**Comments of the California Wind Energy Association on  
CPUC and ISO 50% RPS Special Study for the  
2016-2017 Transmission Planning Process**

July 5, 2015

## PC-21 Heavily Utilized Paths

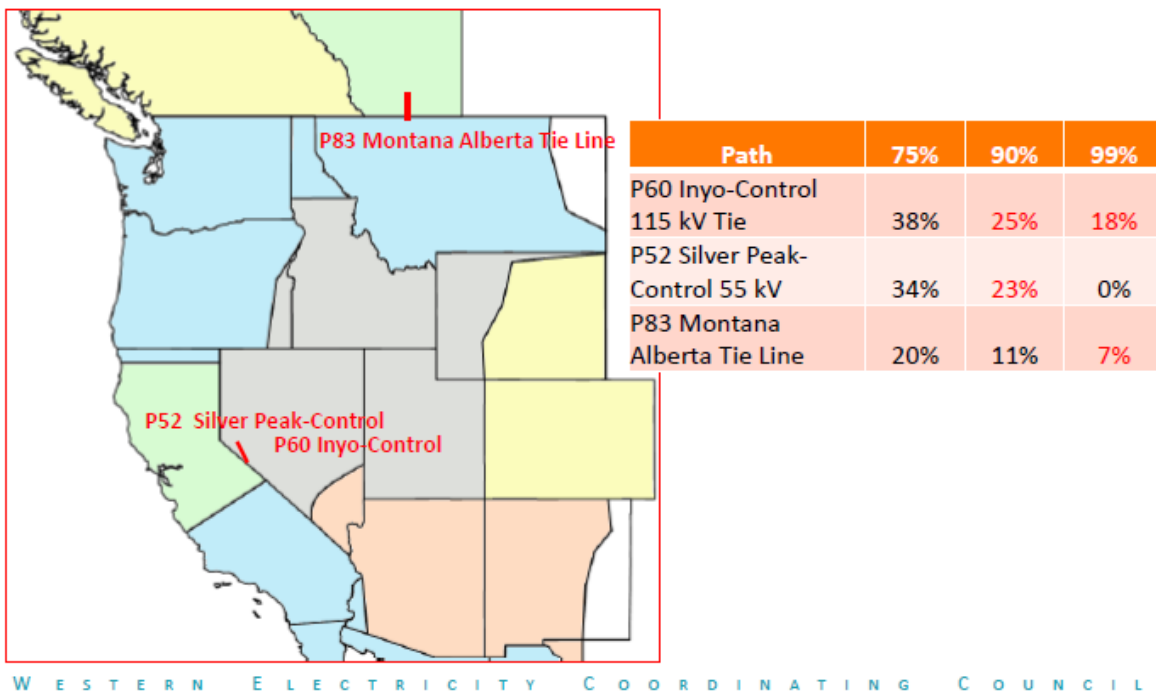
import into California. (See PC-21 slide reproduced below.) Specifically, the following can be gleaned from PC-21:<sup>2</sup>

- The retirement of over 6,000 MW of coal units that are already scheduled to occur by 2024 will enable approximately 3,500 MW of wind energy and 1,800 MW of solar to be accessed through dynamic transfer (DT) arrangements with the CAISO (or via an expanded CAISO) without any transmission upgrades.<sup>3</sup>
- The retirement of 16,000 MW of coal capacity (about half that now operating) would enable 9,600 MW of wind and 4,800 MW of solar to be dynamically scheduled with very modest transmission upgrades.<sup>4</sup>

<sup>4</sup> Slide 11 from the October 2015 WECC presentation shows that just three transmission paths become constrained under PC-21; CalWEA believes these paths can be relatively easily and cheaply upgraded.

This WECC case was not necessarily an optimal one; it was constructed in a certain way for whatever reasons that are not explained on the slides. As part of the Special Study, CAISO and CPUC should develop an optimal level of WECC renewables that considers WECC coal plant retirements and the ability to dynamically schedule renewables into the CAISO, or directly interconnect these renewables in an expanded CAISO.
